Solicitation 1240LU26Q0030
Fort Missoula Bakery Renovation

Amendment 0001

05/07/2026

Existing Interior Doors

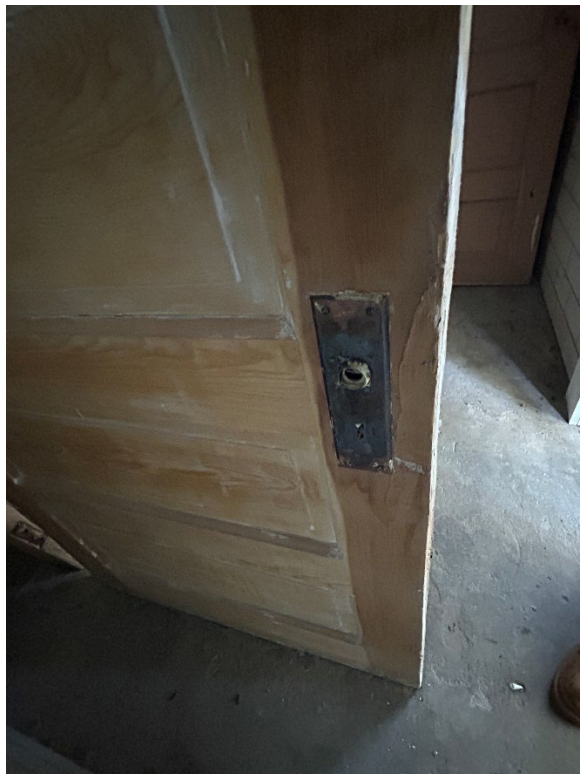
4. The original interior wood doors were recently found. If feasible, use two in the best condition for the bathroom and laundry room doors (105 and 106a in door schedule) in lieu of the door specified in Sections 081433. Include new hardware and paint, removal of existing hardware and modification of the doors to fit the new hardware/fill holes from old hardware. Photos of the doors are below.
